# Impossible Visor Scenario

## STATEMENT REPORT

**Subject:** Impossible visor scenario  
**Type:** Statement  
**By:** Björn Stenberg and Johan Ridderstolpe  
**Status:** Proved  
**Date:** 2000-01-01  
**Version:** Report - English

JAIC figure 3.5

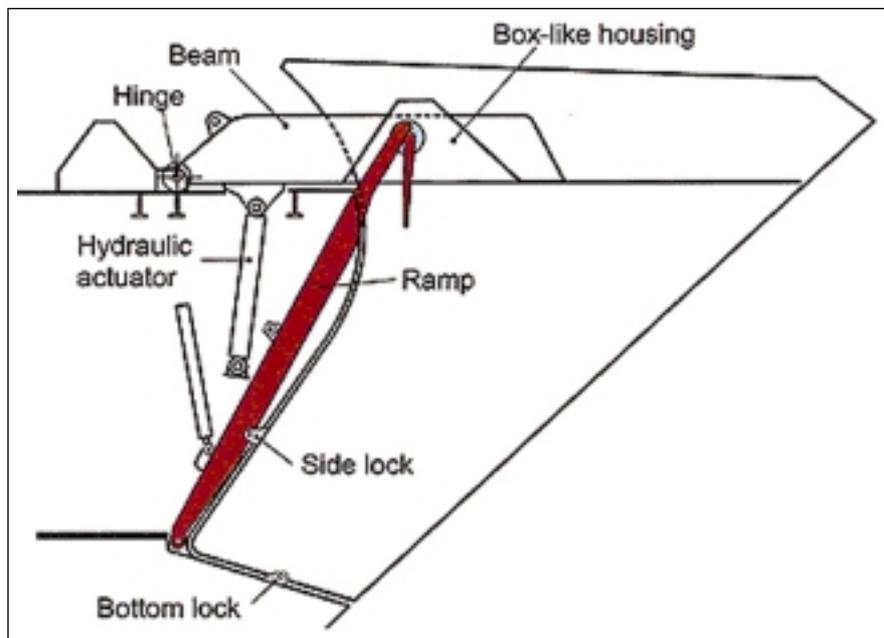
However these locks are not shown in the JAIC figure 3.5.

It is also important to notice that the JAIC figure 3.5 and some other figures in the Commission report showing the ramp in the closed position are incorrect. The upper part of the ramp is "moved" aft so that it will meet the fore part of the upper deck. This illustrates the ramp being closer to the aft part of the visor housing for the ramp than it actually was. The most correct illustration in the final report is JAIC figure 3.6, "Bow visor general arrangement and structure".

Fact Group (FG) picture 1. The picture shows the visor with its bulkhead to the left and right. The circles indicate the different positions for the recesses that would have absorbed any side loads.

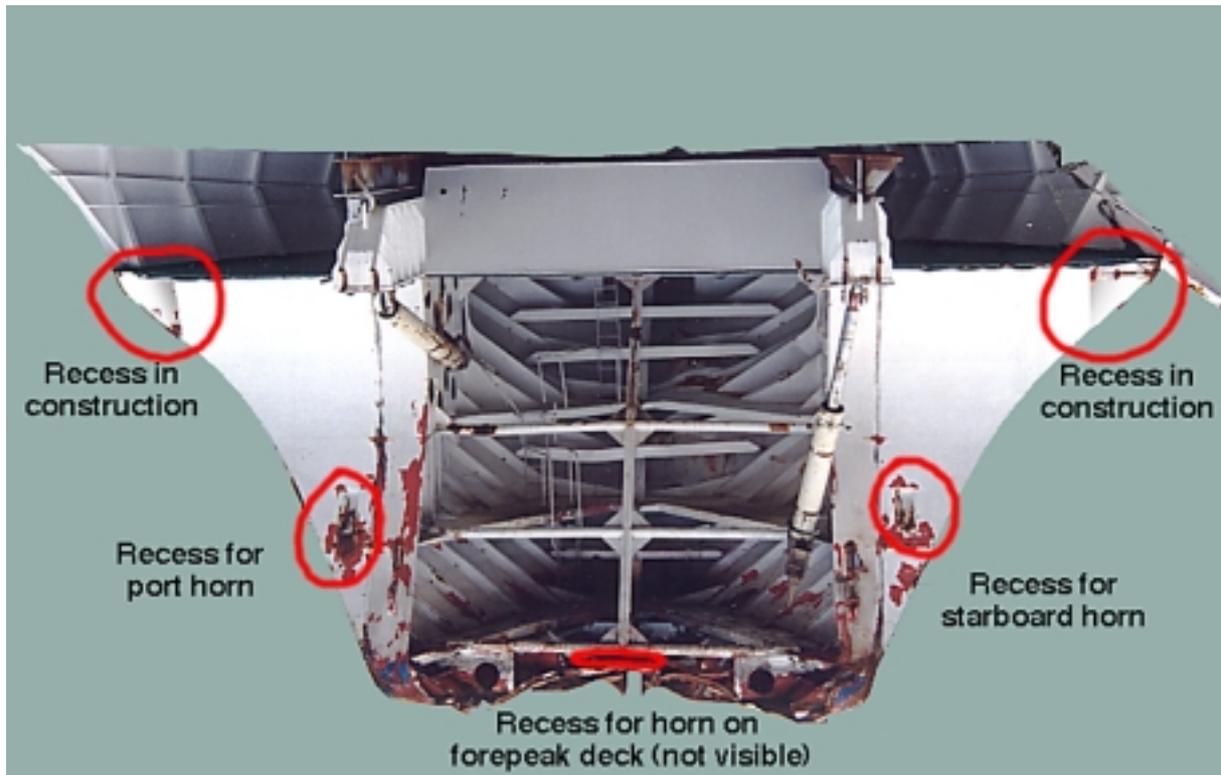
The Commission here stated that "any side loads that might develop" are absorbed by the locating horns. After this correct statement they totally forgot all about the locating horns. They did not take in to consideration the load capacity of the horns and most important, the discharging effect of the wave impact loads on the visor locking devices.

The visor construction was such that, in addition to the three locating horns mentioned by the Commission, there are two upper recesses in the visor bulkhead where the visor engaged with the forward bulkhead in the closed position. This means that if the visor had come loose as a result of any side load, the upper part of the visor with the recess in the bulkhead would also have been damaged.

In reality, none of the recesses are damaged in the side direction.

JAIC figure 3.6 (one of three views shown here)

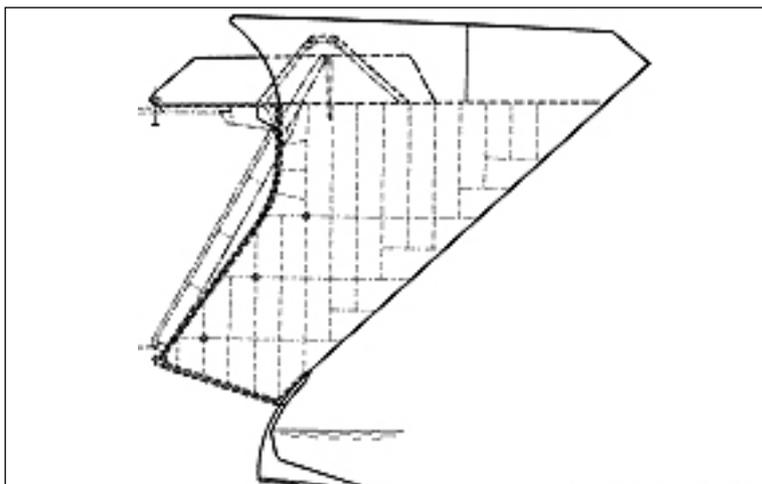
The Commission stated that "The geometry was such that the ramp had to be fully closed in order not to interfere with the visor during its opening and closing".

This conclusion is contradicted by the following observation. Nothing in the visor / ramp geometry would prevent the ramp from being partly opened inside the visor, which can be done without much effort. Because of this it would have been possible to close the visor even if the ramp was not properly closed and locked. Other arrangements with sensors were installed to prevent the visor from being closed if the ramp was not closed and locked properly.

JAIC figure 15.4 "Example of reaction force distribution resulting in port side lock failure."

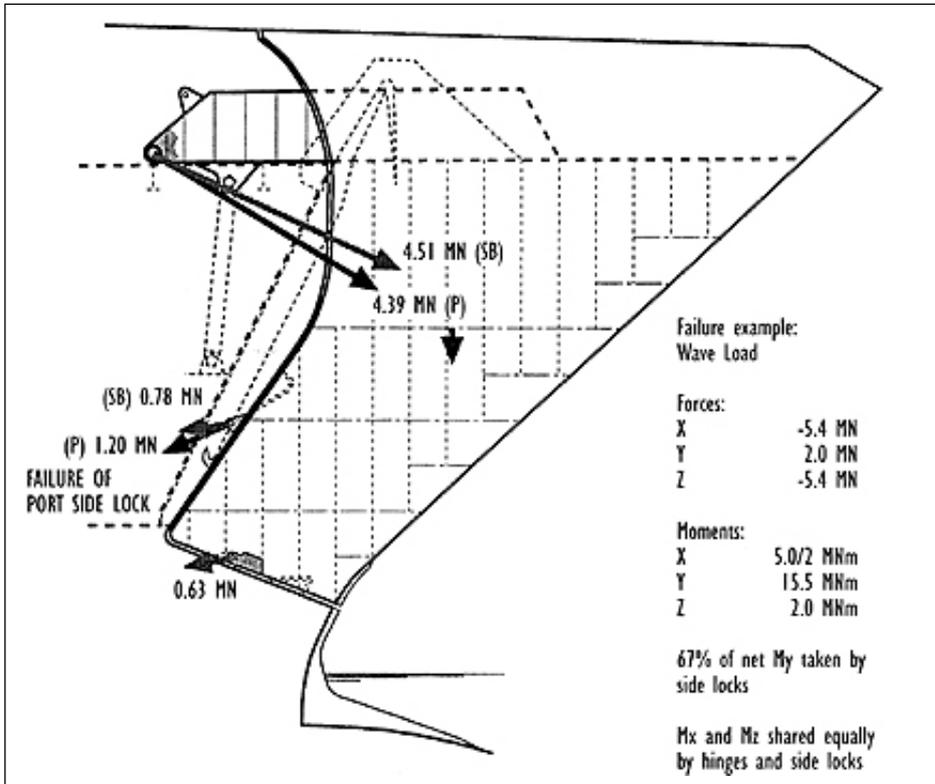
**The Fact Group commentary:**

The Commission failed to calculate the forces that acted on the visor. Instead of using the "resultant force" they used the "reaction force" to prove what force initially broke the visor attachments. They wrongly concluded that the "reaction force" resulted in the port side visor lock failure. Their general conclusion from the supplement (below) also shows that it was based on "may", "could", "seems" and is therefore nothing more than estimates.

JAIC figure 13.6 (two of six drawings shown here)

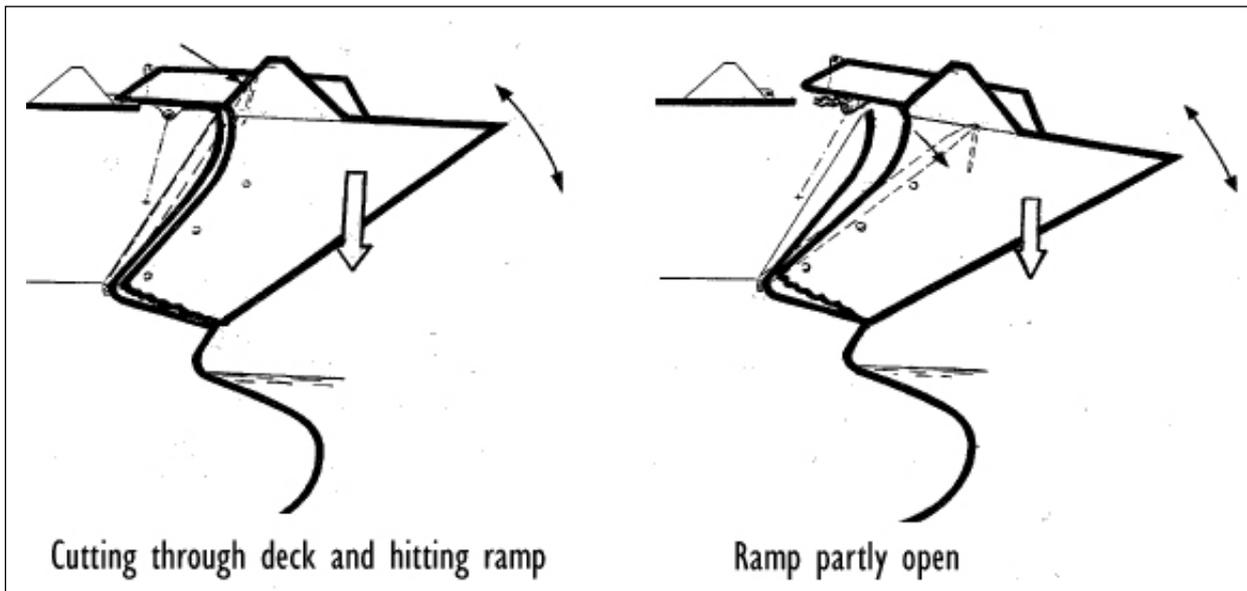
It is important to note that the deck beam is not shown in JAIC figure 13.6 above, though it was found to be the "heaviest structural element preventing the visor from moving forward".
